TRANSMITTAL OF VARIANCES TO PROJECT SPECIFIC PLANS

VARIANCE / FIELD CHANGE NOTICE

PROJECT TITLE: PSP for Area 8, Phase I Pre-certification Real-Time Measurements (21000-PSP-0001)

PROJECT TITLE: Area 8 Phase I Pre-Certification Real-Time Measurements (21000-PSP-0001)

FIGURE 2-2. REAL-TIME MEASUREMENT AREAS IN A8PI

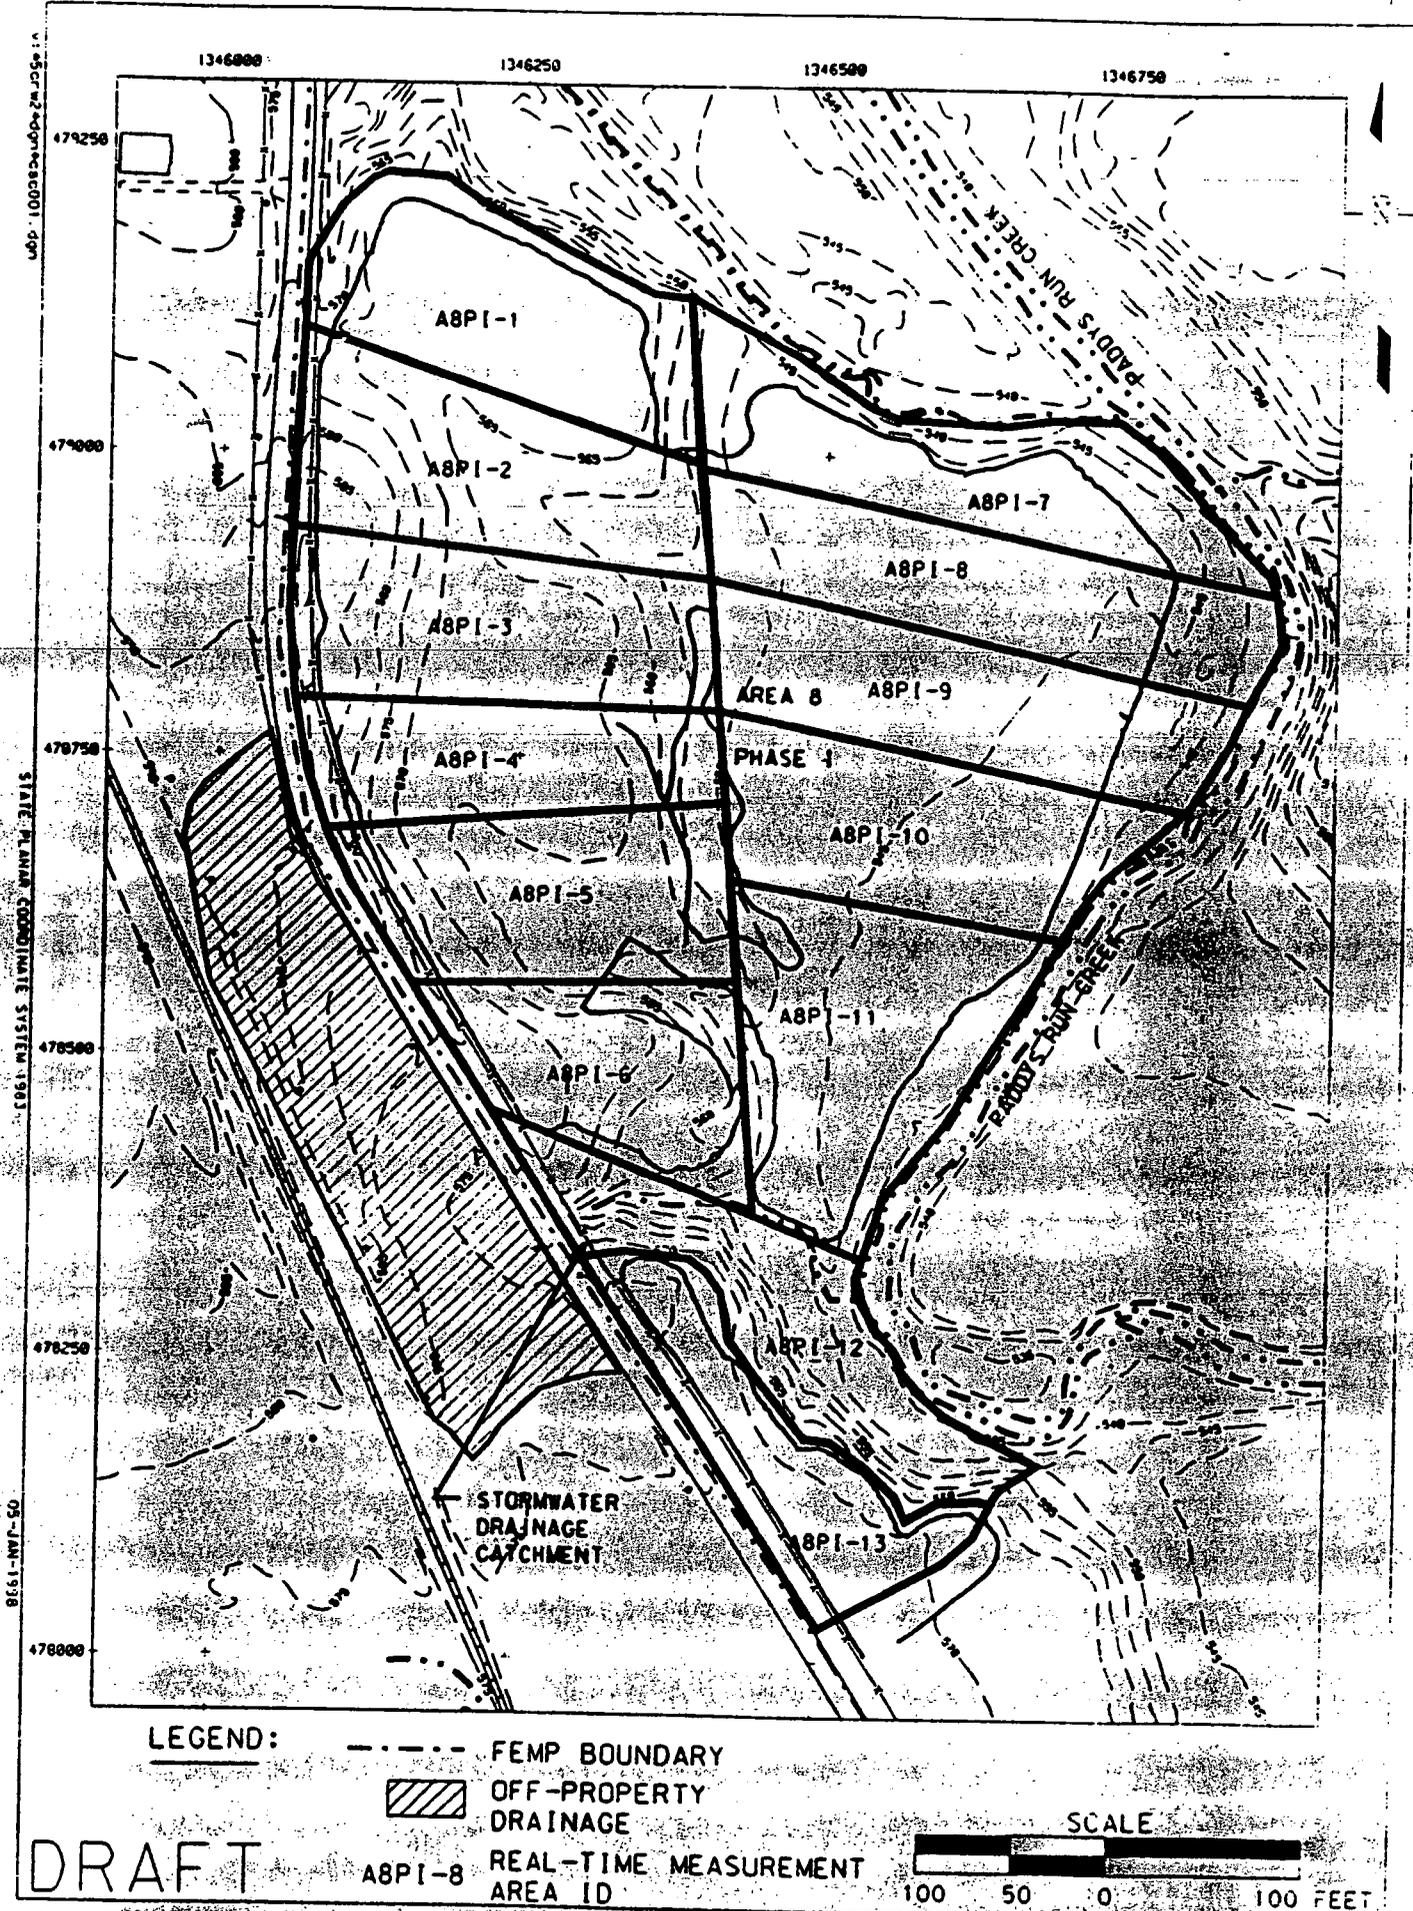
Area 8 phase I consists of thirteen (13) pre-certification real-time measurement areas. These areas are shown in Figure 2-2. The figure is to be used to guide NaI and HPGe measurement strategies.

This variance documents delineation of Real-Time measurement areas within remediation area 8 Phase I.
